NorthConnex

Environmental Impact Statement

Submissions and Preferred Infrastructure Report
Chapters 5 - 7

Submissions and preferred infrastructure report

Figure 7-1 Forecast traffic volumes (PCU) relative to traffic design capacity

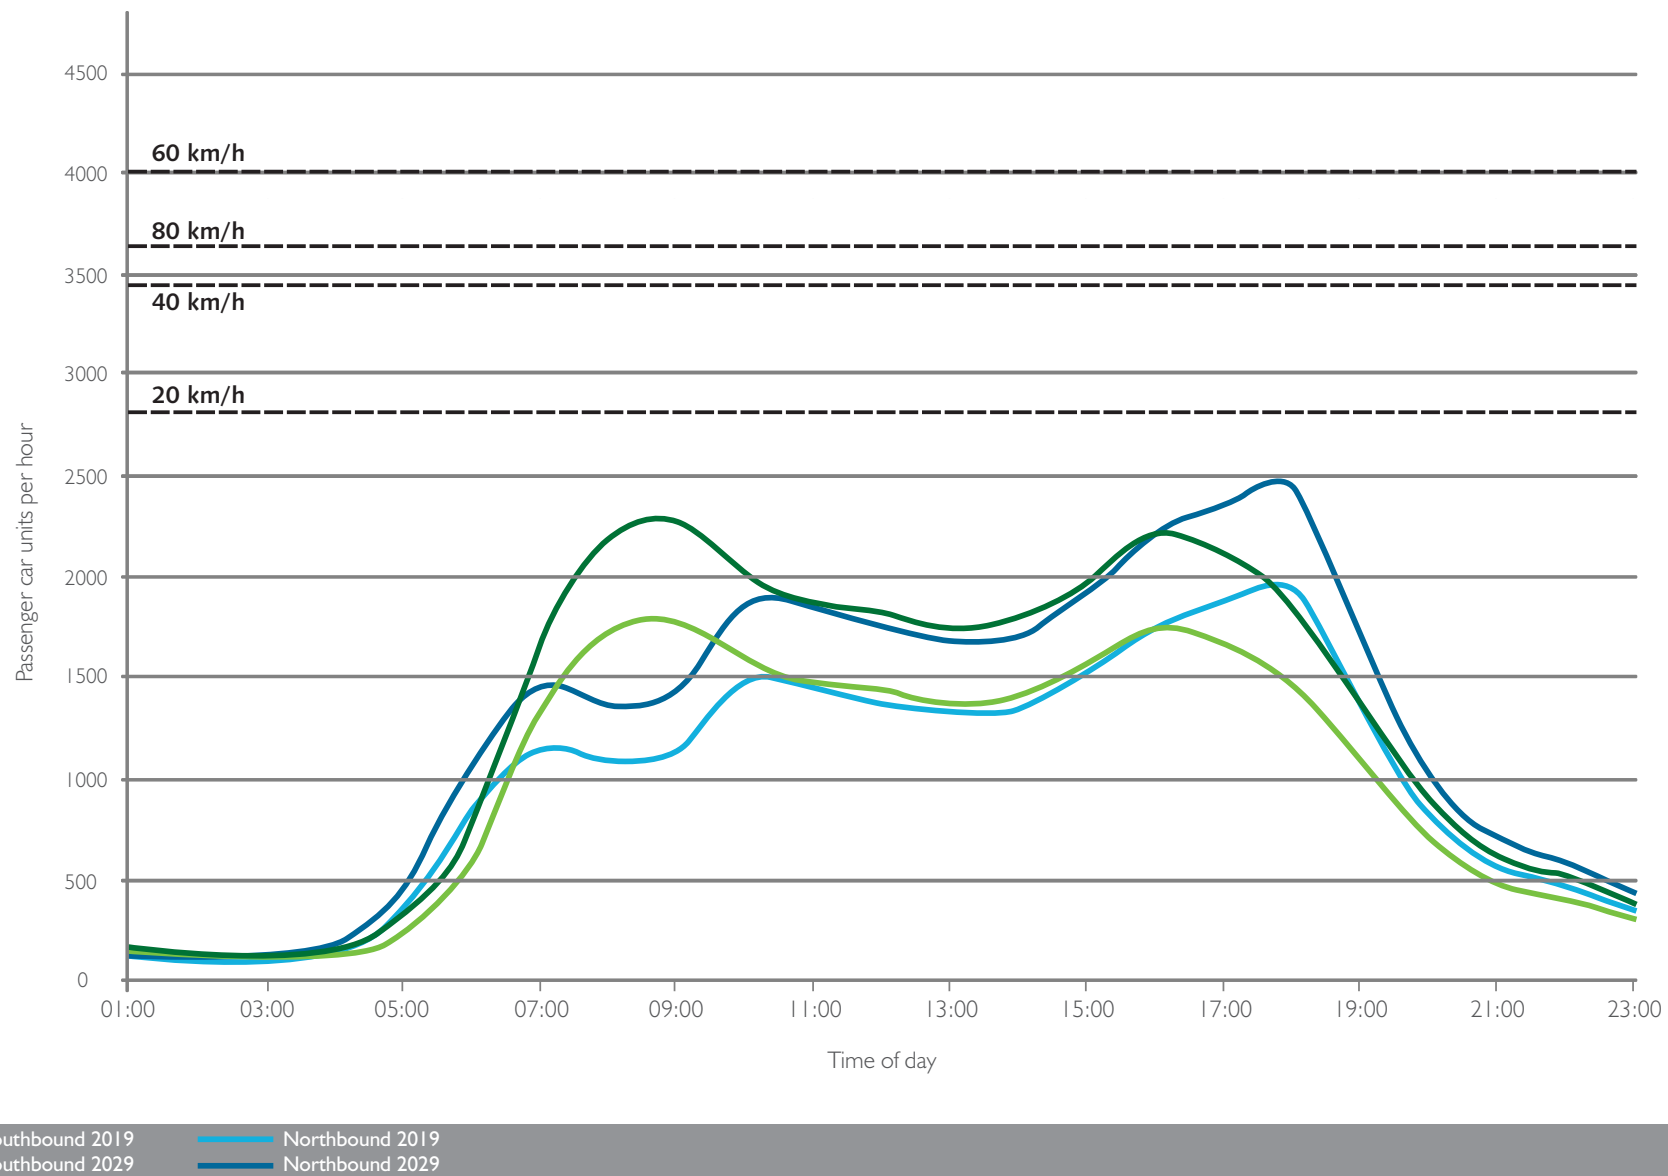
There are certain inputs into the air quality assessment, for example traffic modelling, where the Environment Protection Authority is an end user of this data and does not have relevant technical expertise to provide a meaningful review. For the purposes of the air quality impact assessment review, the Environment Protection Authority has assumed the traffic modelling completed for the project and adopted in the air quality assessment is accurate.

The Environment Protection Authority does not have sufficient expertise to provide comment on the traffic modelling in any detail.

These forecast traffic data can be compared with the maximum traffic design capacity of a two lane motorway (refer to **Figure 2-1**) provided below. The comparison demonstrates that peak forecast traffic flows in 2019 and 2029 for both the southbound and the northbound main alignment tunnels would be comfortably below the maximum traffic design capacity down to an average traffic speed below 20 km/h.

Figure 7-1 shows the forecast traffic volumes for the project, as passenger car units, relative to the maximum traffic design capacity of the southbound and northbound main alignment tunnels in 2019 and 2029.

Figure 7-3 Average in-tunnel NO_2 concentrations for various international road tunnels (NHMRC, 2008 and RMS, 2014)

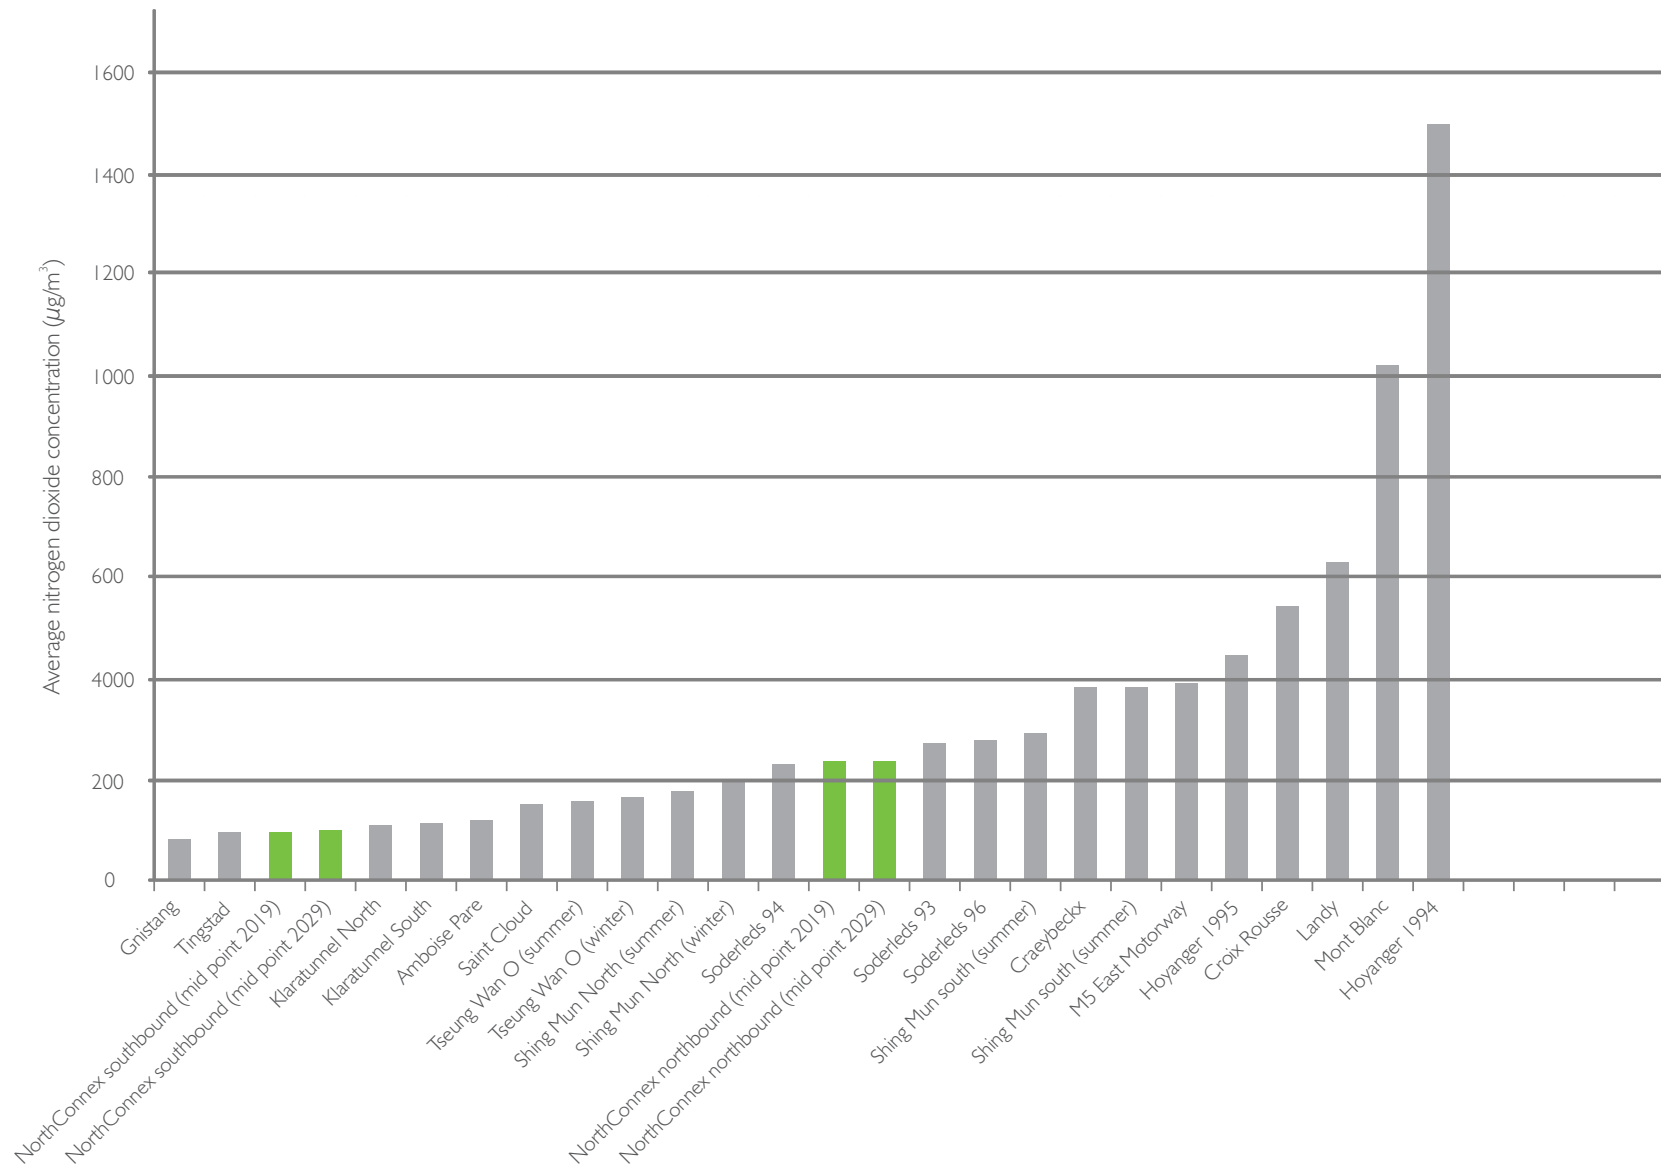
Figure 7-31 (page 523 in the environmental impact statement) describes predicted PM_{2.5} levels substantially higher than those recorded in the M5 East tunnel when PIARC emission factors are used.

The distribution of reported NO₂ concentrations in other road tunnels provided in the National Health and Medical Research Council report (2008) can be plotted with similar calculated concentrations for NorthConnex project to illustrate the variability and range of international road tunnel performance (rather than for the purpose of direct comparison, as noted above). **Figure 7-3** shows the National Health and Medical Research data, and includes calculated average NO₂ concentrations on a similar 24 average basis at the main alignment tunnel mid points in 2019 and 2029.
